Agenda
Village of Arlington Heights
Design Commission
Community Room, 3rd Floor

Arlington Heights Village Hall
33 S. Arlington Heights Road
Arlington Heights, IL 60005
May 23, 2017
6:30 PM

**MINUTES OF
THE VILLAGE OF ARLINGTON HEIGHTS
DESIGN COMMISSION MEETING
HELD AT THE ARLINGTON HEIGHTS MUNICIPAL BUILDING
33 S. ARLINGTON HEIGHTS RD.
APRIL 25, 2017**

THE SORENSON RESIDENCE
1715 N. MITCHELL AVE.
ARLINGTON HEIGHTS, IL 60004

Job Number: 17067
Sheet Number: A200
File Name: 17067200

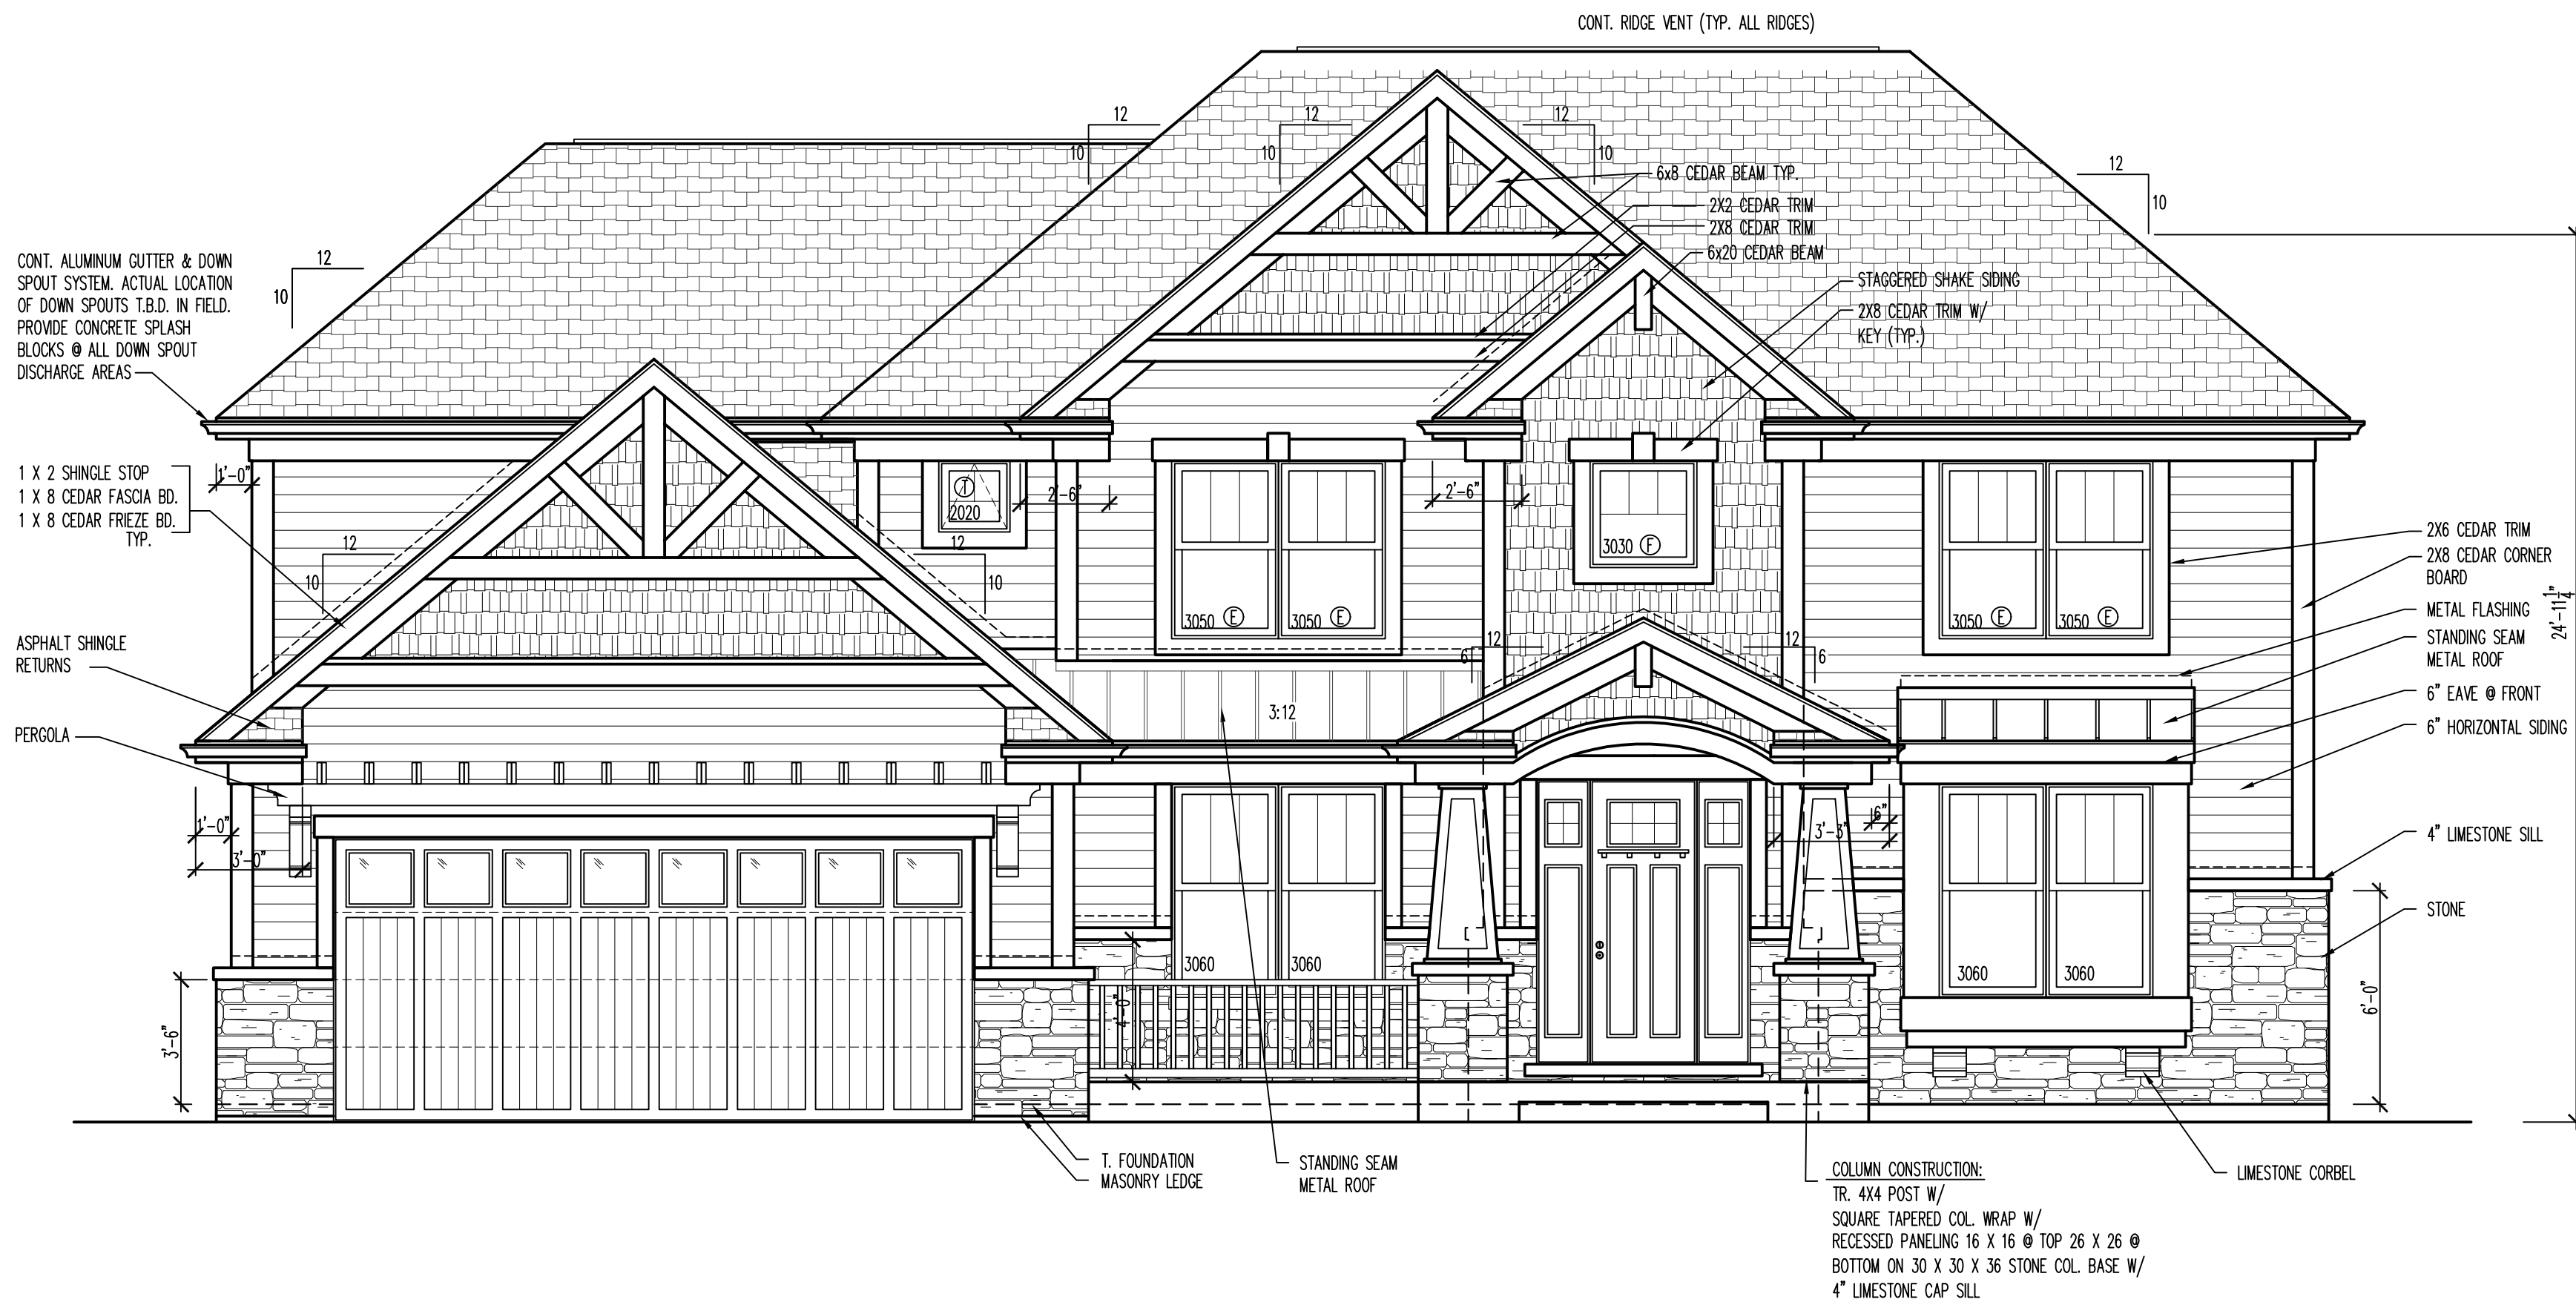
1. Reduce the roof pitch on the sides from 10:12 to 8:12.
2. Add a window in the side of the garage.
3. Add windows in Bedroom 3 and Bedroom 4 on the right side elevation.

4. Add detailing to the rear elevation. Consider a portico roof above the patio door or a small box bay window at the kitchen sink.
5. This review deals with architectural design only and should not be construed to be an approval of, or to have any other impact on, any other zoning and/or land use issues or decisions that stem from zoning, building, signage or any other reviews. In addition to the normal technical review, permit drawings will be reviewed for consistency with the Design Commission and any other Commission or Board approval conditions. It is the architect/homeowner/builder's responsibility to comply with the Design Commission approval and ensure that building permit plans comply with all zoning code, building permit and signage requirements.

1. Reduce the scale of the gable above the garage and the overall roof by reducing the roof pitch on the sides from 10:12 to 8:12.
2. The stone is nicely returned down the side of the garage. To further enhance the appearance, it is recommended to add a window in the side of the garage.
3. The right side elevation second floor has no windows. It is recommended to add a window in Bedroom 3 and Bedroom 4.
4. The rear elevation needs some detailing to tie it in with the rest of the design. Consider a portico roof above the patio door or a small box bay window at the kitchen sink.

**SITE PLAN
ROOF PLAN**

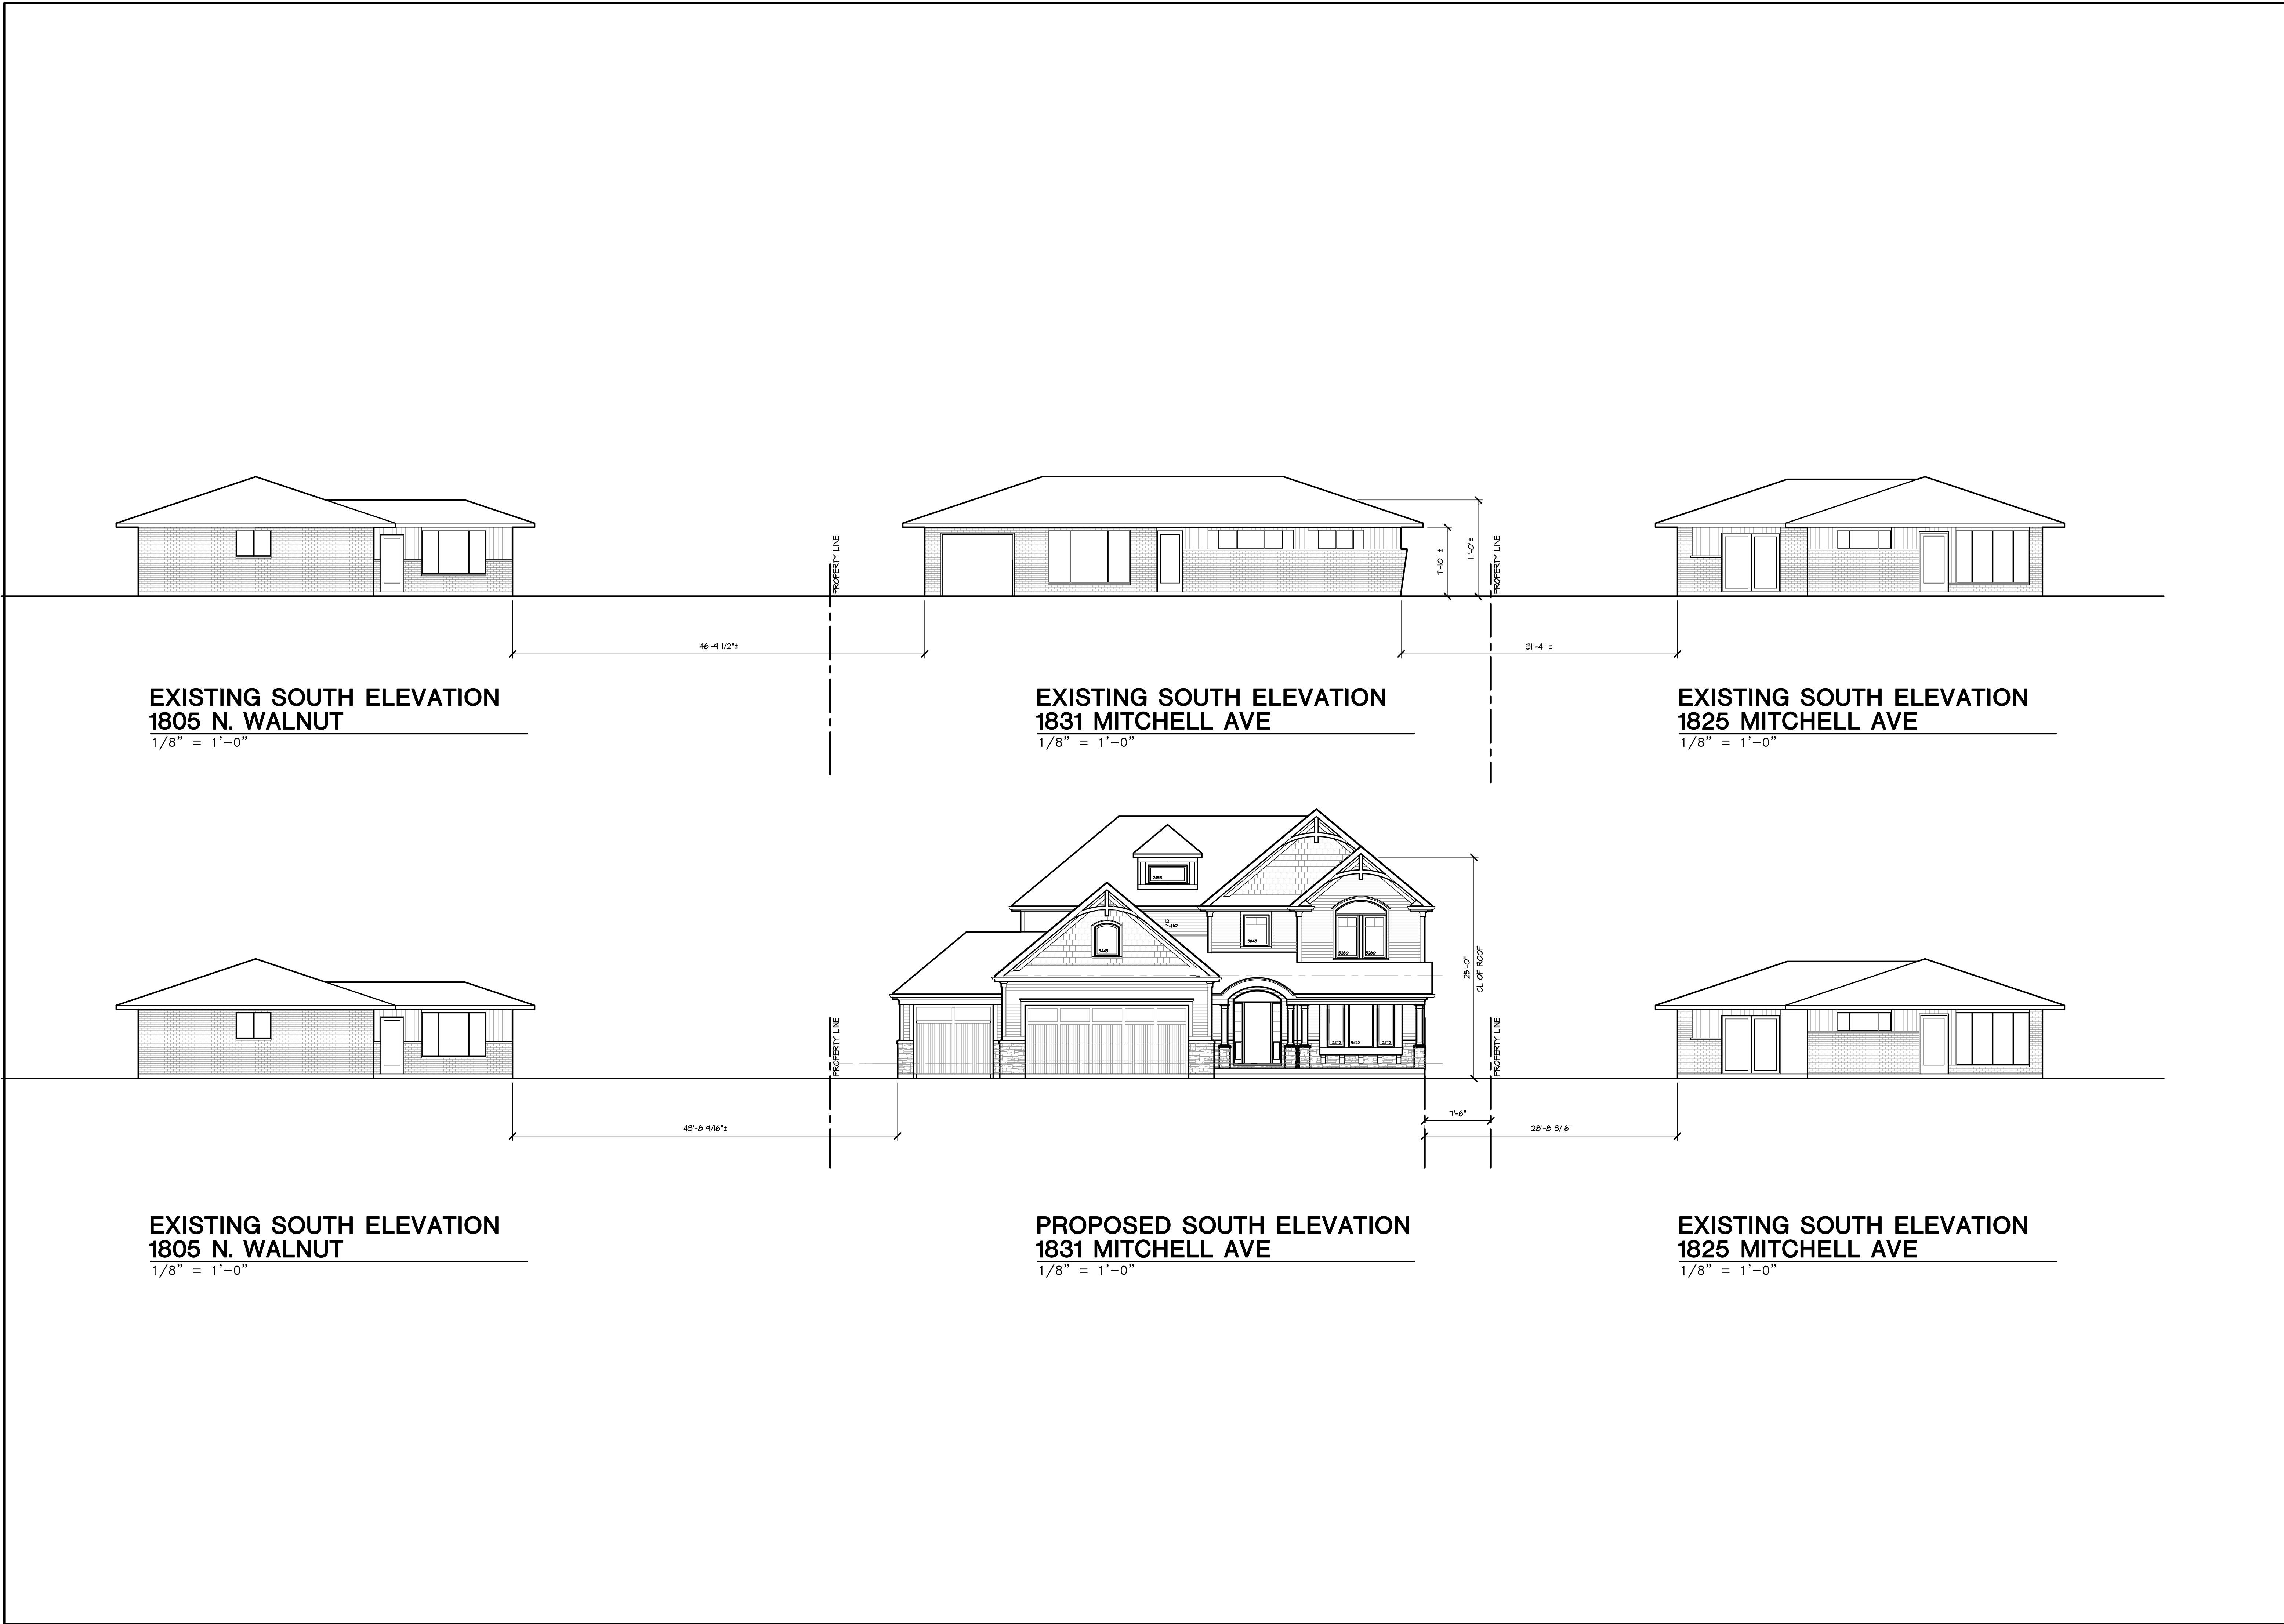
5. Add a window in the side of the garage.
6. Extend the stone a few feet on the east elevation.
7. Add grids to all of the windows to match the front elevation.

1. Reduce the scale of the gable above the garage and the overall roof by reducing the roof pitch on the sides from 10:12 to 8:12.
2. Pull the porch forward a couple of feet so that the garage is not the most prominent feature.
3. The dormer on the roof gives the house a three story appearance, so it is recommended to be omitted.
4. The side of the garage will be highly visible, so it is recommended that the stone be returned all the way down the side and a window added.
5. The stone should be returned a few feet down the east side elevation, to align with the second floor wall above.
6. All windows should have window grids to match the front elevation.

Renovated Exterior
Elevations

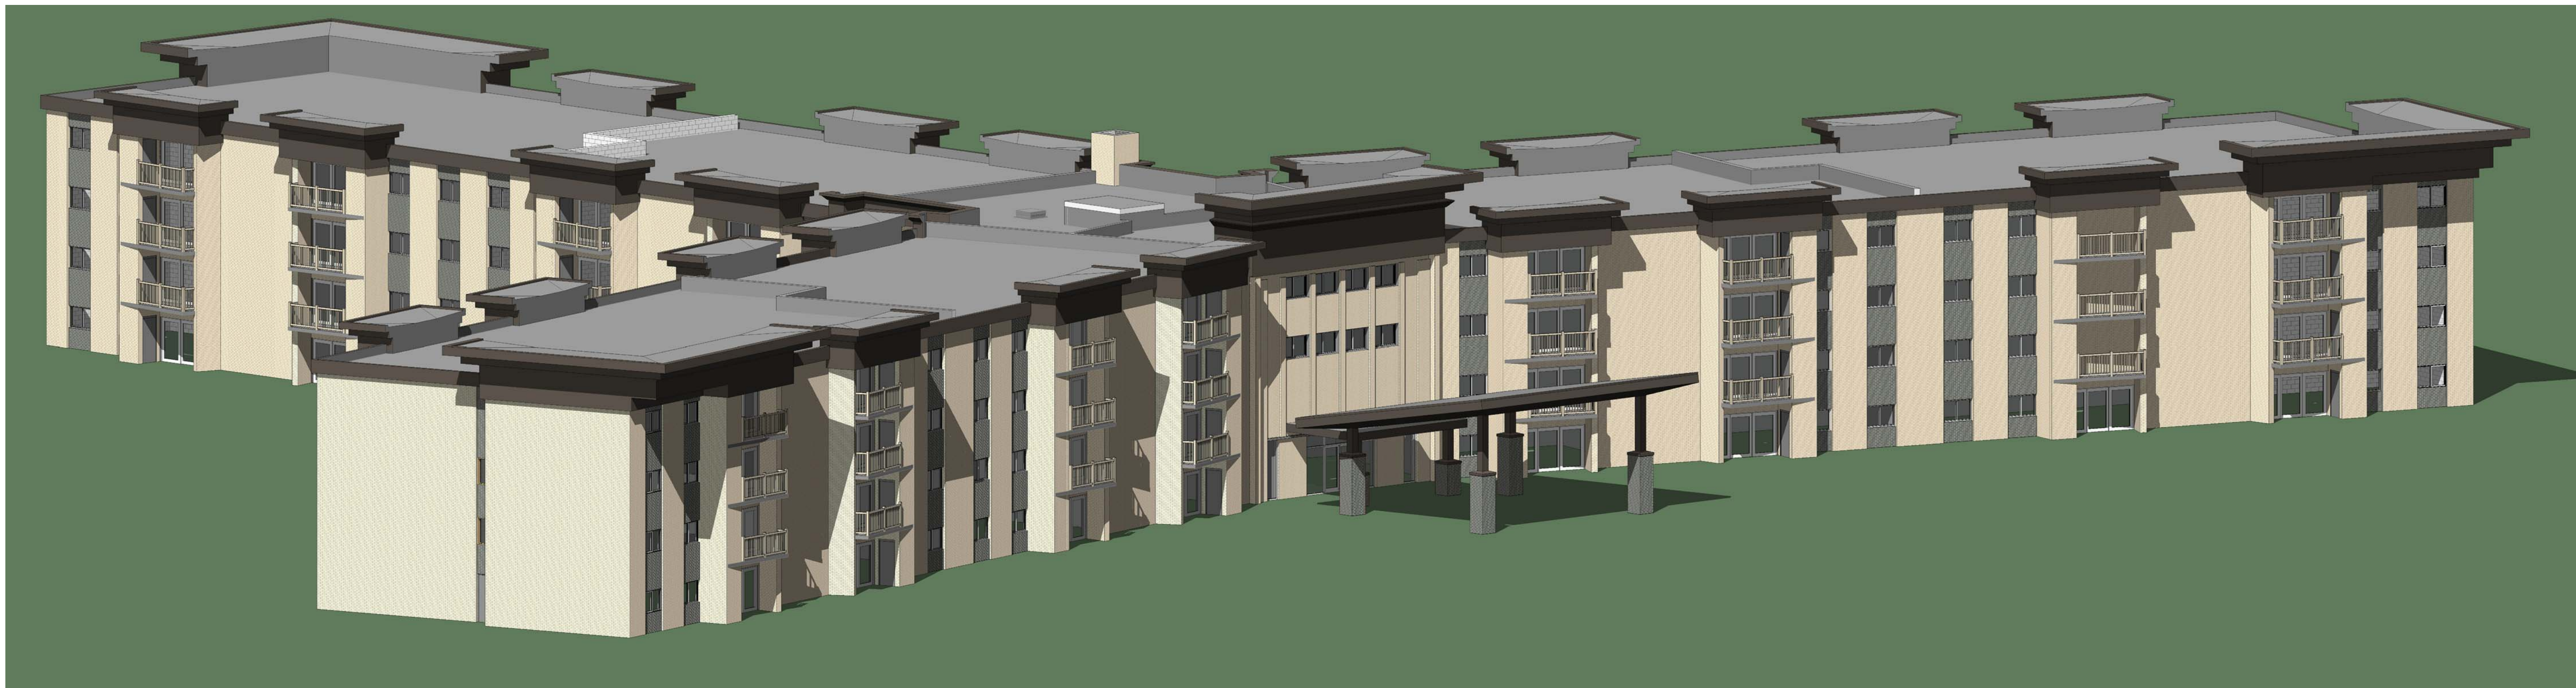
1. Cornices. Overall, Staff is in support of the concept to use a bold decorative cornice to give the buildings a fresh, modern appearance. However, portions of the proposed cornice design look a bit heavy and bulky, especially in the dark black color. Additionally, the profile of the cornices is a simple stepped design. Consider incorporating a slope into the bottom of the profile to add more interest to the design. The scale, profile, and color of the proposed cornices should be evaluated by the Design Commission.

1. Evaluate the scale, profile, and color of the proposed cornices. Consider incorporating a slope into the bottom of the profile to add more interest to the design.
